**Agenda Item:** 7.7  
**Source:** Siemens AG  
**Title:** RRC Connection Establishment and Release for TDD  
**Document for:** Decision

This document contains deltas which may be added to S2.03, "UE Functions and Interlayer Procedures in Connected Mode" [2].

## 2 RRC Connection Establishment for TDD mode

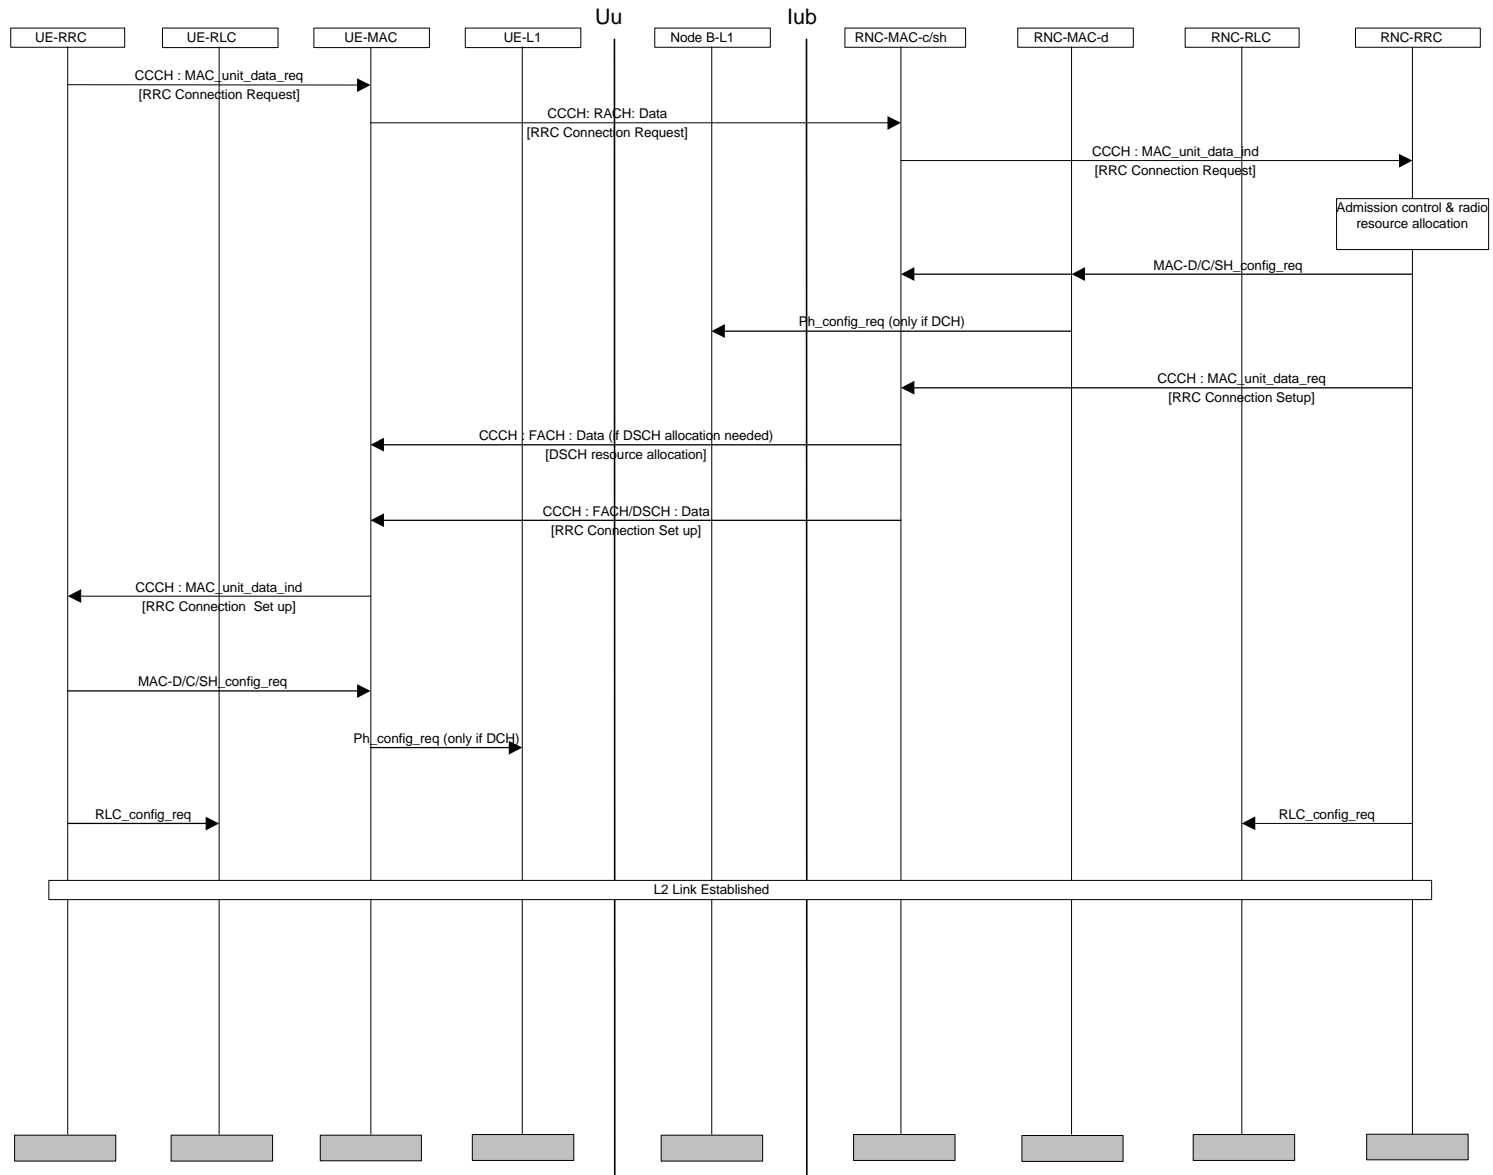
- add the figure as well as the text from *chapter 2 of this Tdoc* as chapter 9.1.1.1, "RRC connection establishment for TDD mode" into S2.03, and
- add the figure and the text from *chapter 3 of this Tdoc* as chapter 9.1.4.3, "RRC connection release for TDD mode" into S2.03.

In the following, only the differences to FDD are described.

At the RNC side, the configuration of RNC-MAC-d and RNC-MAC-c/sh is done with *one message* MAC-D/C/SH\_config\_req because these MAC entities are assumed to be in the same RNC and one message is therefore sufficient.

The configuration of NodeB-L1 in case of DCH is done by SRNC-MAC using the message "Ph\_config\_req".

For transmission of the "RRC Connection Set Up" message, either the FACH or the DSCH can be used. If the DSCH is used, there will be a DSCH resource allocation message in the FACH before.

In the UE, the configuration of UE-L1 in case of DCH is done by the UE-MAC using the message "Ph\_config\_req". Any L1 synch procedure during channel set up is not required in TDD.

### 3 RRC Connection Release for TDD mode

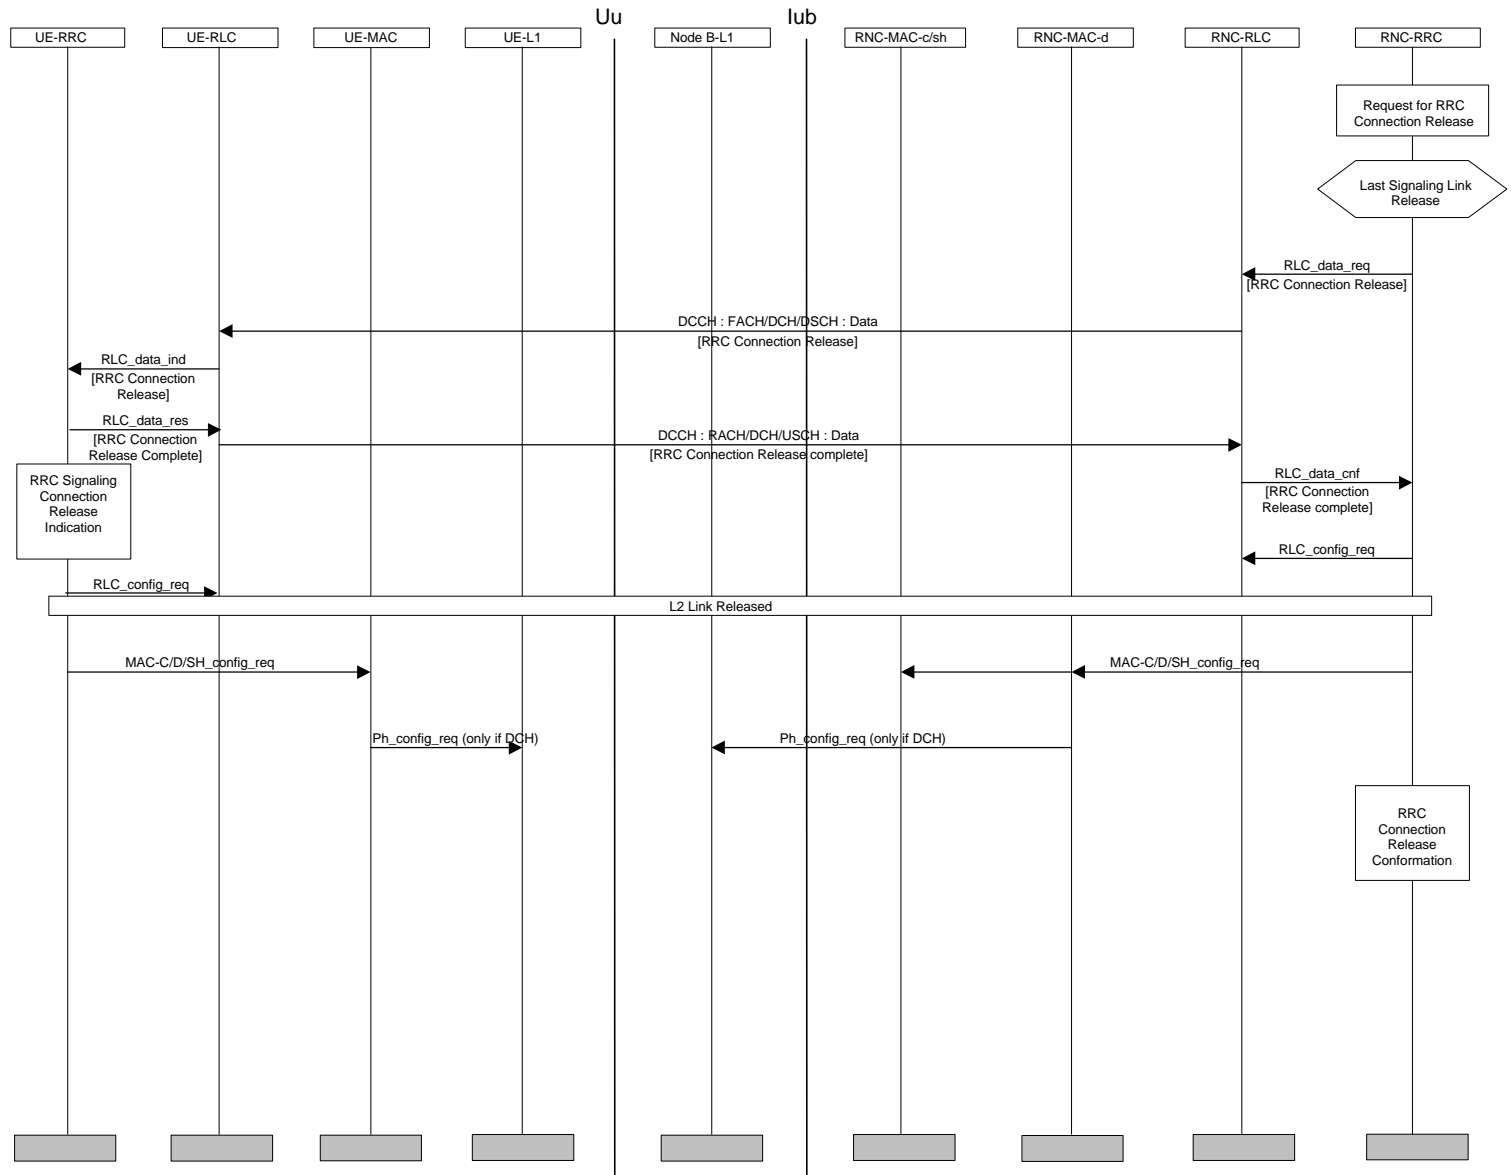
The RRC connection release for TDD is similar to the "RRC connection release without Dedicated Physical Channel" in FDD because in TDD, the RNC-RRC expects the "RRC Connection Release Complete" message from the UE as an acknowledgement and does not rely on the "MPH\_out\_of\_sync\_ind" to see that the DCH has been terminated.

In the following, only the differences of the TDD RRC Connection Release procedure compared to the "RRC connection release without Dedicated Physical Channel" procedure in FDD are described.

The "RRC Connection Release" message from RNC to UE is sent as "Unacknowledged data" because the acknowledgement is expected at RRC level, not at RLC level.

The UE responds by sending the "RRC Connection Release Complete" message as "Unacknowledged data".

At the RNC side, the release of the MAC connection is performed with one primitive "MAC-D/C/SH\_config\_req" from RRC to MAC because the several MAC entities serving the UE are all located in the same RNC.

A potential release of L1 in case of DCH is performed on both sides by MAC-d using a "Ph\_config\_req".
